ADDENDUM # 1

5P201-17-5050

Installation and Mechanical and Electrical Components Replacement at the Carillon Navigation

ADDENDUM N° 1

Answer: refer to question 2

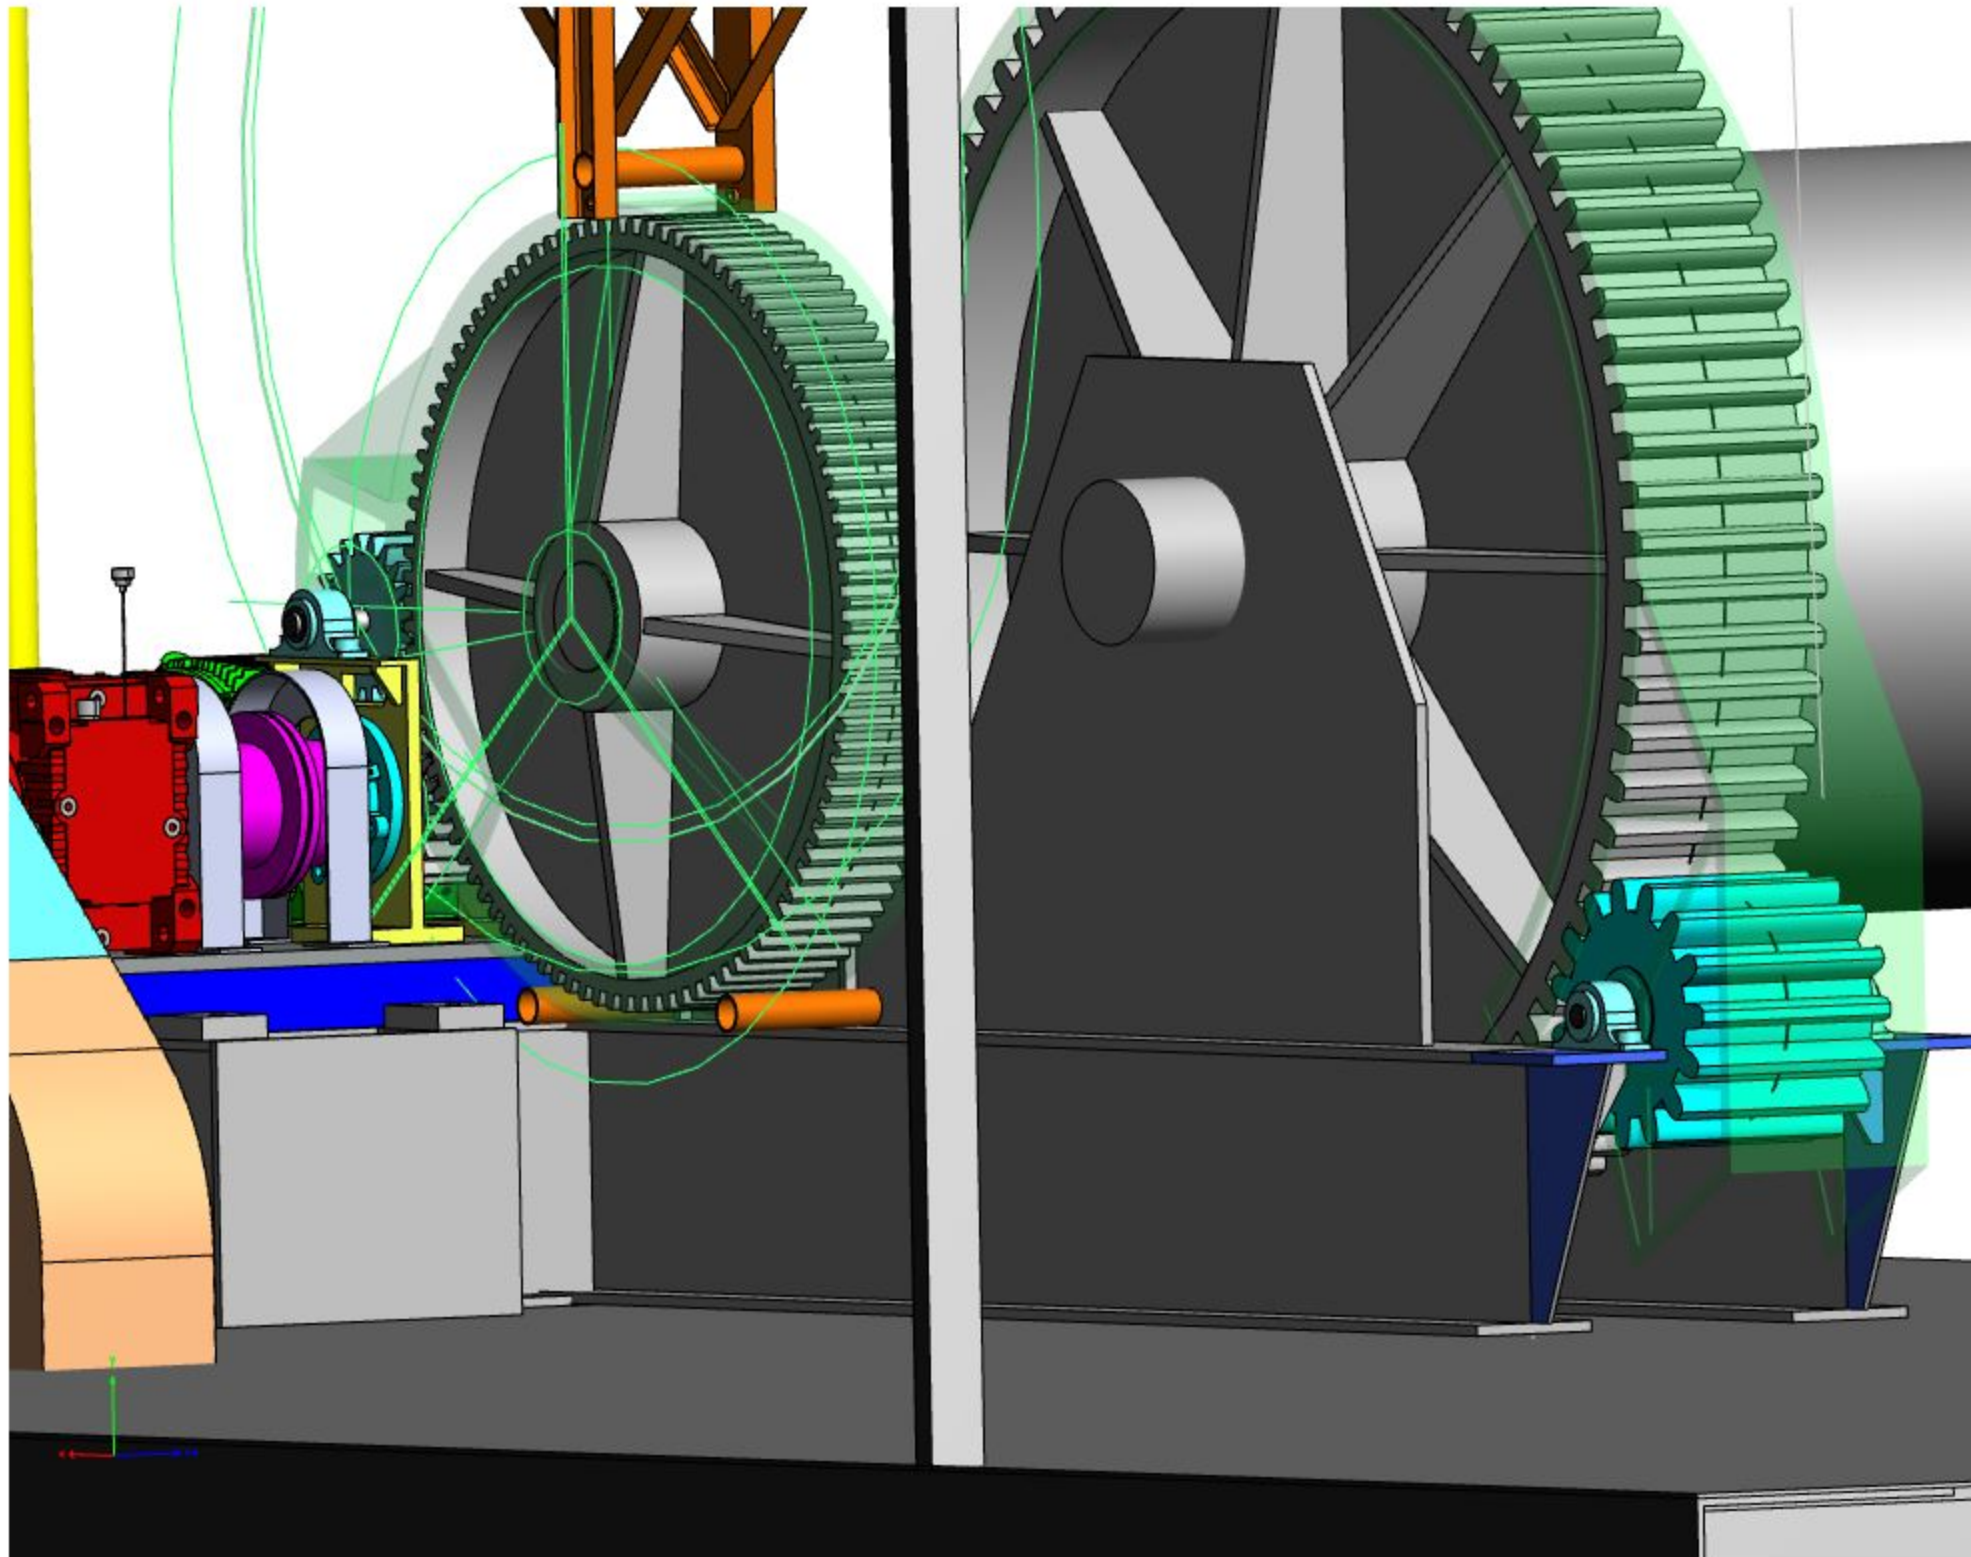
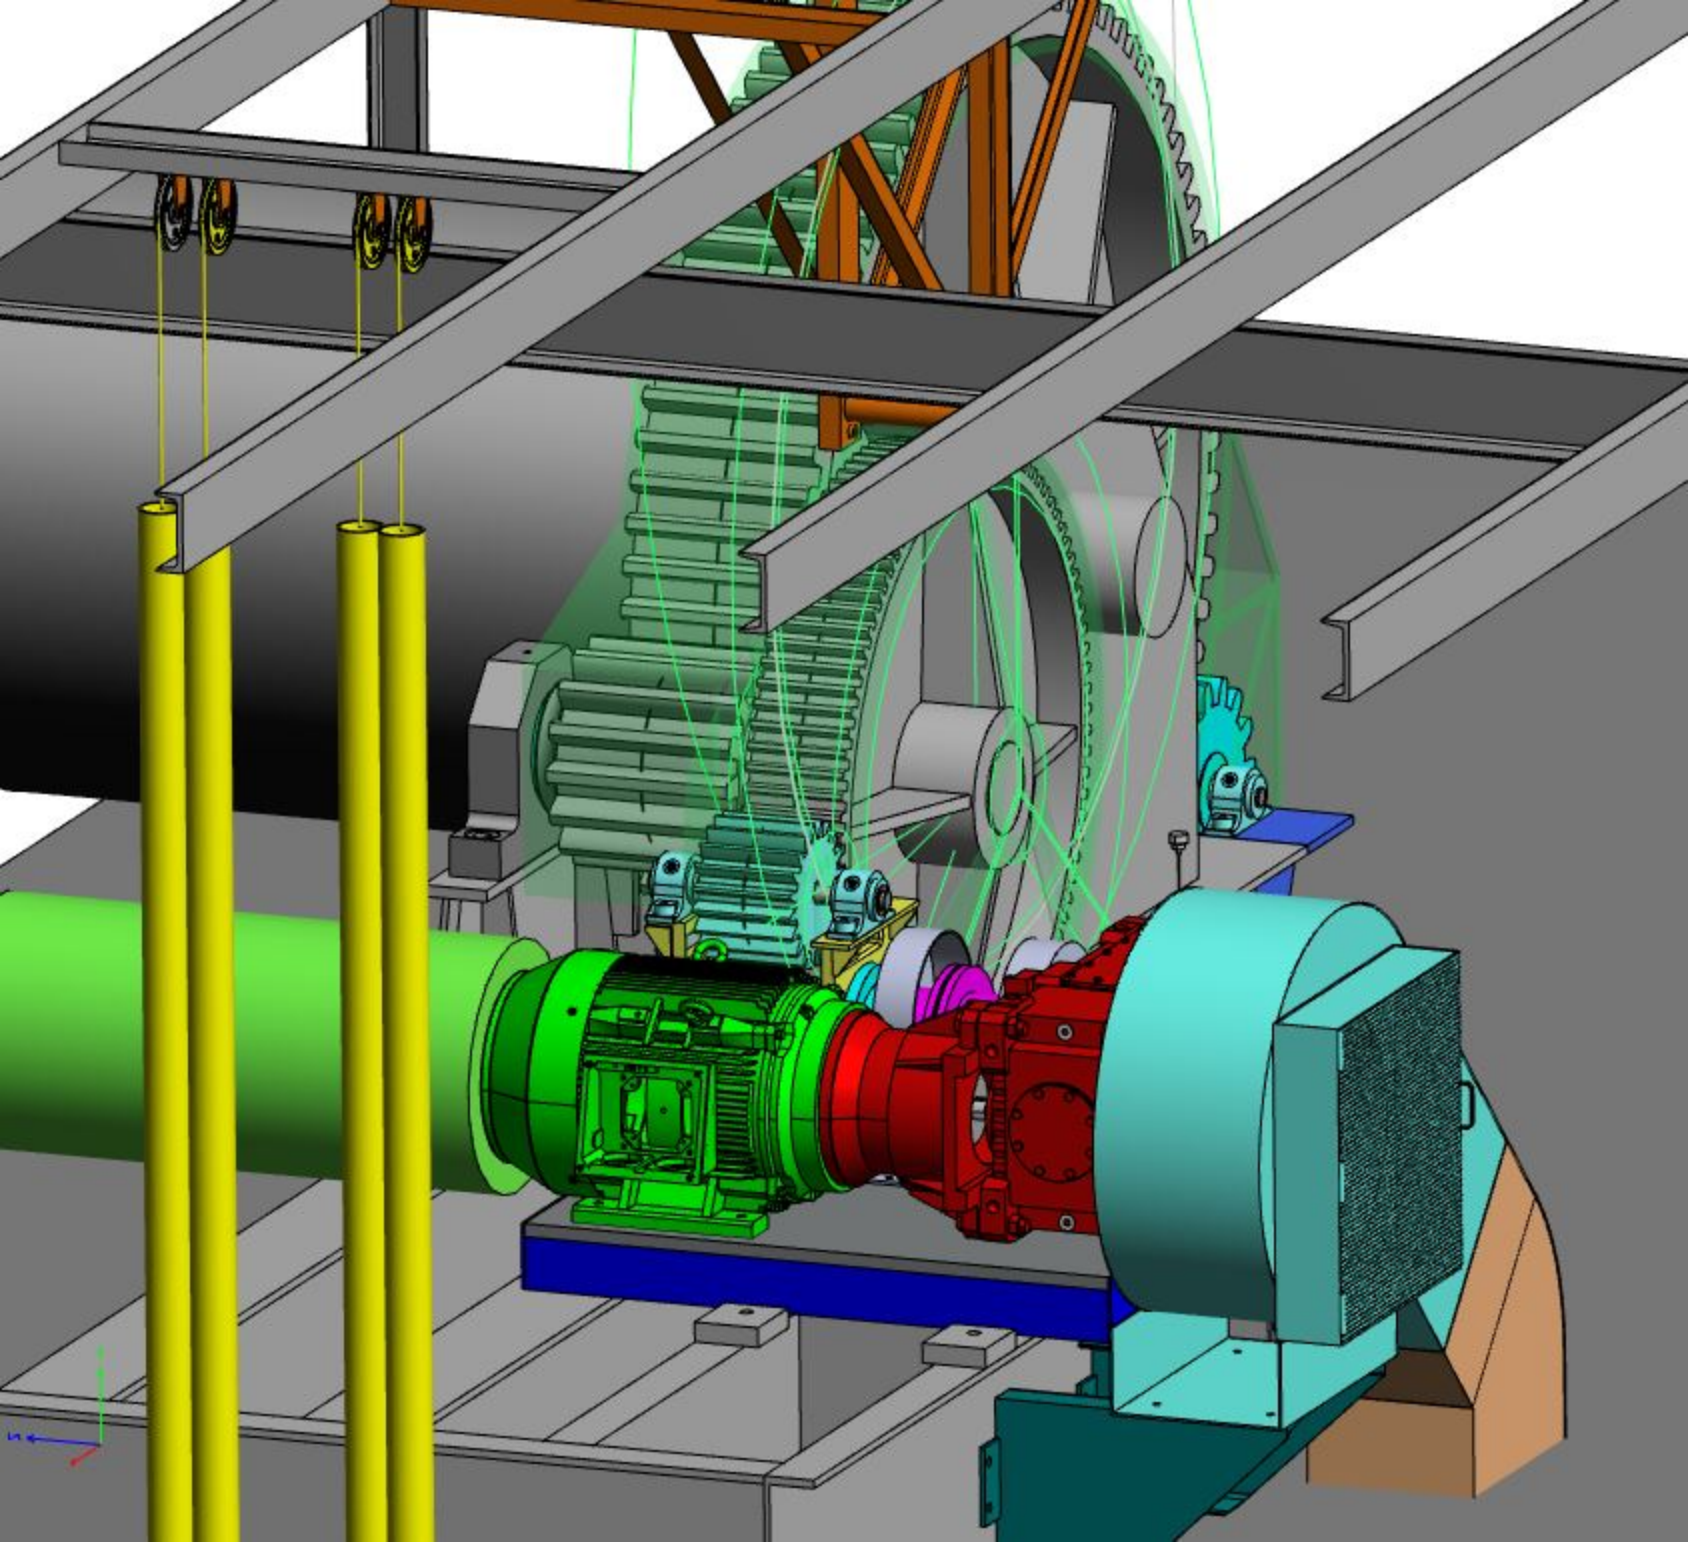
13. To facilitate understanding, see attached 3D for the works at the vertically door.
